SIERRA CLUB MARYLAND CHAPTER (FULL SUBMITTAL)

Re: Comments on I-495 & I-270 Managed Lane Study Supplemental Draft Environmental Impact Statement and Updated Draft Section 4(f) Evaluation

Figure 1: Northbound Inner Loop Throughput 5-6 p.m. – 2017 from DEIS, 2045 from SDEIS

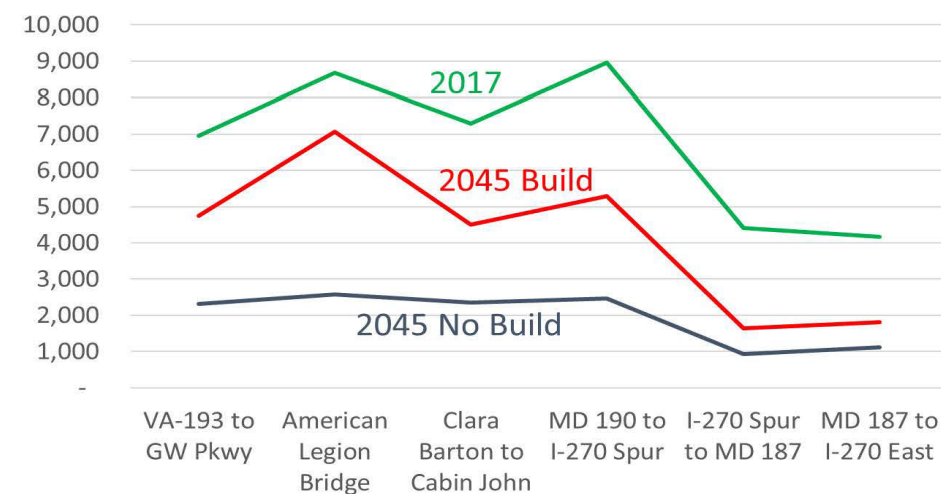
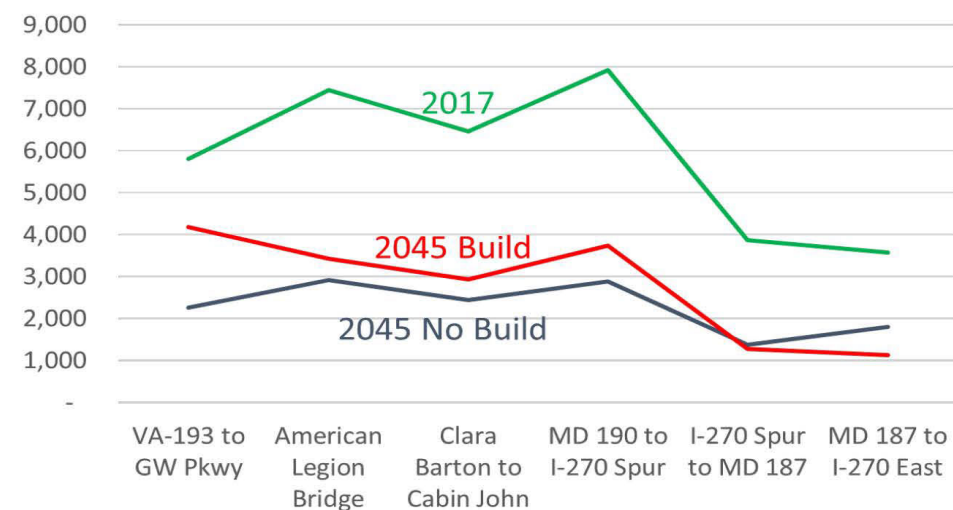
There is no real-world rationale for future throughput being significantly lower than today. Without widening, throughput will be very similar to today because the road is already congested. With widening, throughput also will be very similar to today because traffic flow will be metered by the downstream bottlenecks. The SDEIS compares two sets of wrong 2045 throughput numbers and presents the difference between them as a performance metric. This is invalid.

In the DEIS, the Inner Loop afternoon peak hour volume (5-6 p.m.) on the American Legion Bridge is reported to be 8,760 vehicles per hour. This segment has 5 travel lanes today, so the average volume is 1752 vehicles per lane per hour. In the SDEIS future Build model, 2 managed lanes are added so there would be a total of 7 lanes. The SDEIS reports the throughput as only 3,430 vehicles in the 6-7 p.m. hour, i.e., less than 500 vehicles per lane per hour – less than the traffic volumes on city streets interrupted by traffic signals. This is obviously wrong.

Figure 3: Preferred Alternative 2045 Inner Loop American Legion Bridge Demand, Throughput and Cumulative Unserved Demand (Queue) in the Afternoon Peak Period

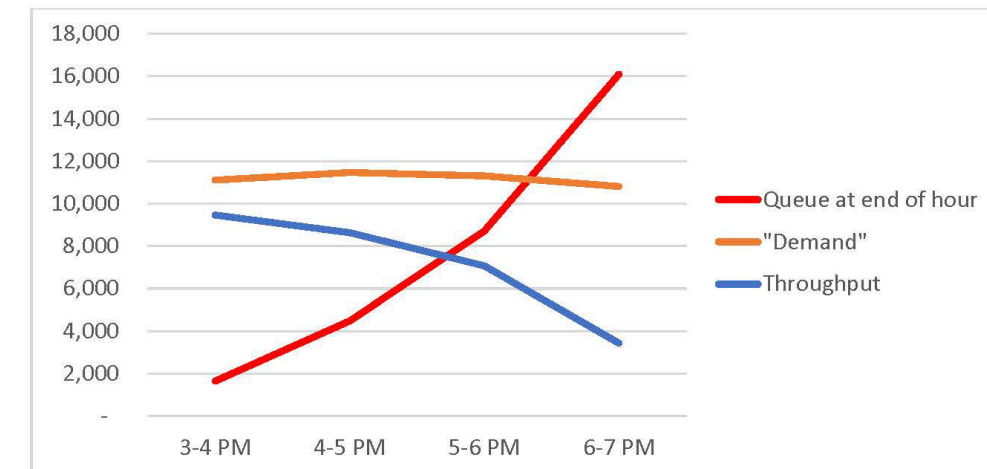
The VISSIM model is overwhelmed by the “garbage in” “demand” and translates it into unrealistically- low throughput. The SDEIS calls the difference between “demand” and “throughput” “demand unserved.” During the afternoon peak period (3 -7 p.m.) in the inner loop there is unserved demand in each of the four hours, and the VISSIM model queue becomes longer and longer through 7 p.m. This queue of cumulative unserved demand is not reported in the SDEIS but is easily calculated from the demand and throughput numbers. Figure 3 shows demand, throughput, and cumulative unserved demand.

Assuming that there is no traffic backed up at the beginning of the simulation (3 p.m.), the traffic backup (queue) grows exponentially over the 4 hours of the afternoon simulation to over 16,000 vehicles at 7 p.m. Clearing this accumulated queue in VISSIM would require many hours of additional simulation

Figure 6: Impossible Traffic Forecasts in MWCOG 2040 No Build Afternoon Peak Period (Segments with Volume/Capacity Greater than 1.1 Shown in Red)⁵⁴

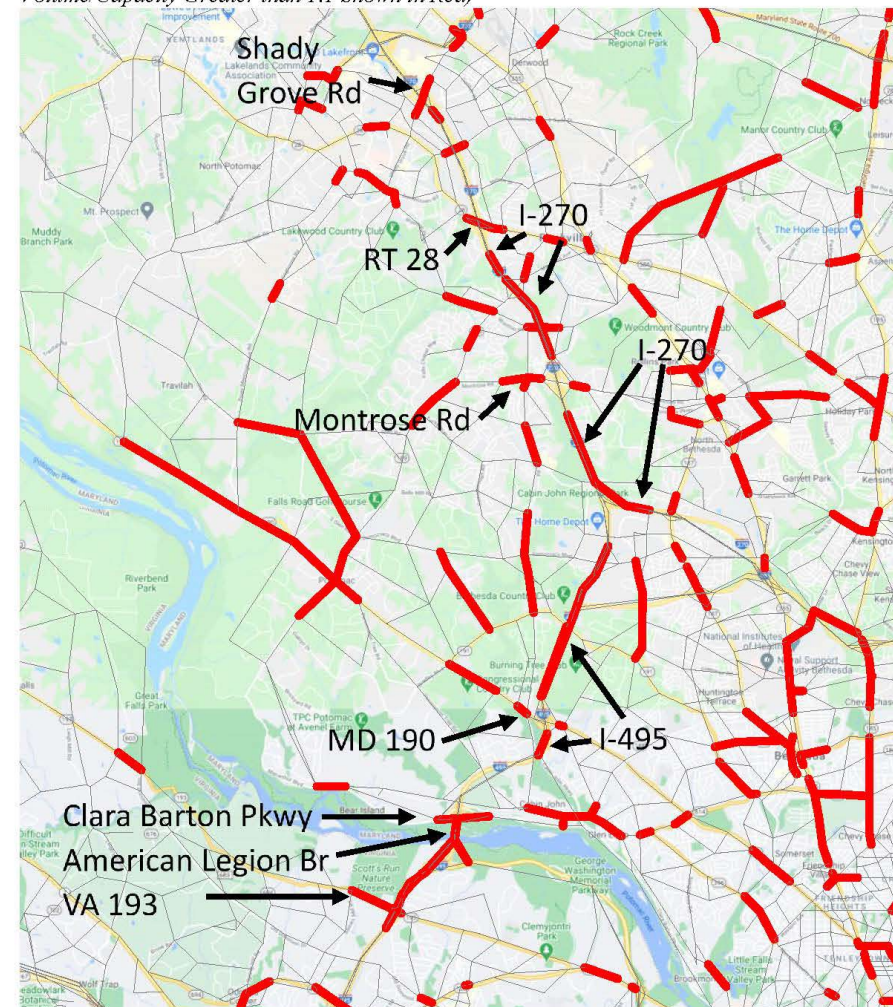
In the DEIS, many segments of I-495, I-270 and other roads are loaded with v/c greater than 1.1 (Figure 6). Horowitz admonishes that the DEIS modeling should not be published with v/c > 1.1. Therefore, these model results should not be used for planning purposes. The DEIS not only does publish these modeling results and uses them for planning, but even goes so far as to represent these over-capacity assignments as a performance measure. This claim is false and is rebutted in the Appendix B of this report section (Section II.F).

Figure 7: Wildly Impossible Potomac Bridge Traffic Forecasts in MWCOG 2040 No Build Morning and Afternoon Peak Periods

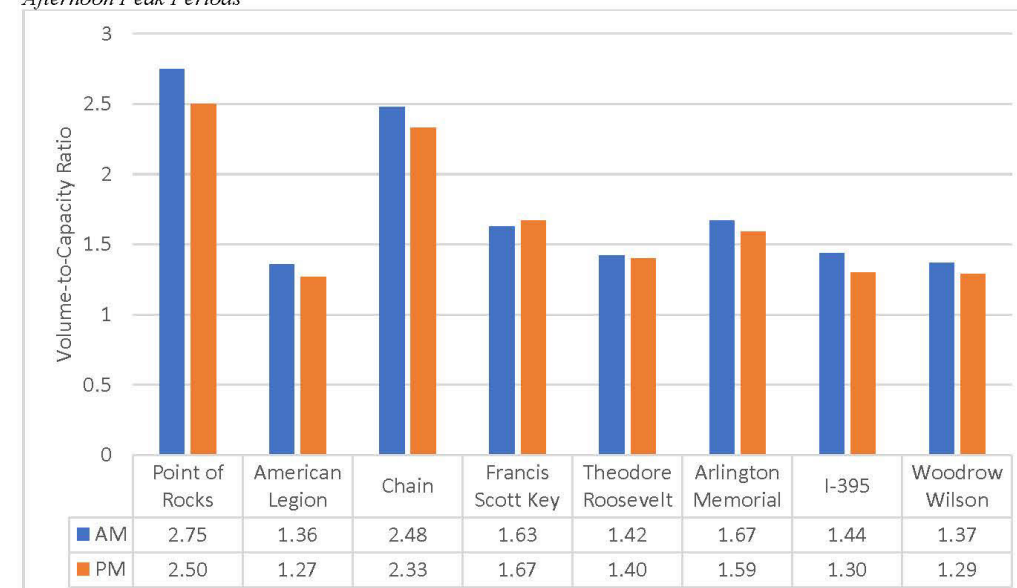
In the DEIS 2040 no build model, MWCOG morning and afternoon peak period traffic volumes for all Potomac River bridge crossings are ridiculously high (Figure 7). All greatly exceed the 1.1 volume-to-capacity ratio threshold, and range as high as 2.75, i.e., the bridge traffic volume is 275% of the highest possible volume.

Figure 12: 2040 No Build Regional Afternoon Peak Period VHD – Road Segments with Possible v/c ≤ 1.0 vs. Impossible v/c > 1.0

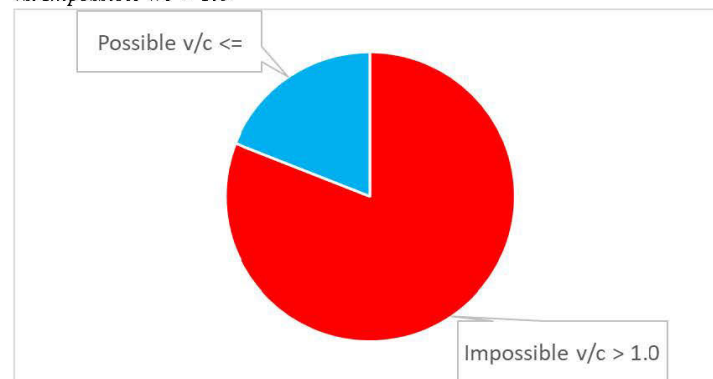
As shown in Figure 12, most (81%) of regional afternoon peak period VHD in the 2040 no build modeling is from impossible assignments with volume-to-capacity ratio exceeding 1.0. The exponential increases in modeled delay as a function of V/C makes MWCOG model VHD more of a metric of model errors than a metric of real-world performance.

The DEIS VHD calculations are invalid. However, even if they were valid, they do not provide a compelling case for the proposed managed lanes Project. Figure 13 takes the DEIS VHD numbers for a combination of Montgomery and Prince George's Counties and divides by current and 2040 population so the alternatives can be compared on a per capita basis.

Figure A1: Maryland DEIS Daily Traffic Data and Forecasts (Tables 3-1 and 3-2)

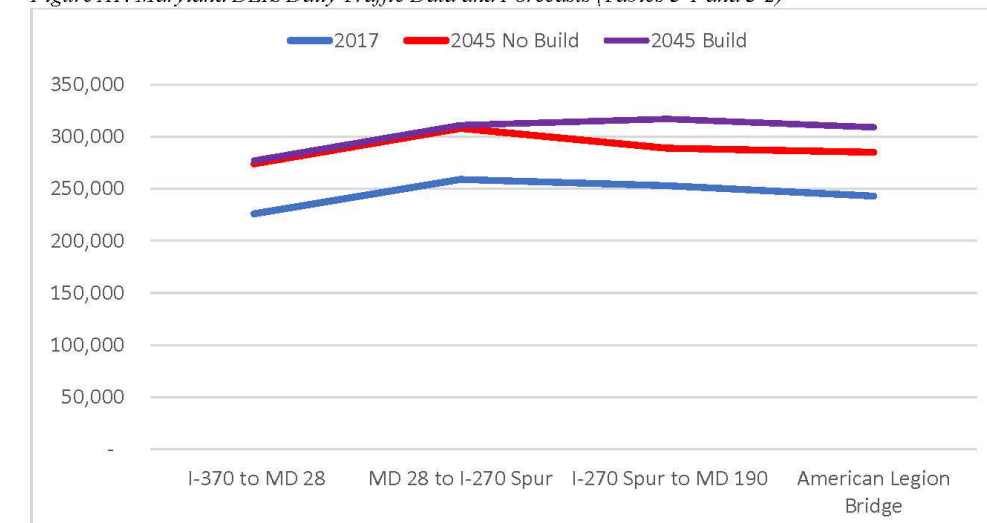
Figure A1 shows SDEIS daily traffic data and forecasts for I-495 and I-270. The SDEIS forecasts significant traffic growth in the 2045 no build alternative and only slightly higher growth for the build alternative.
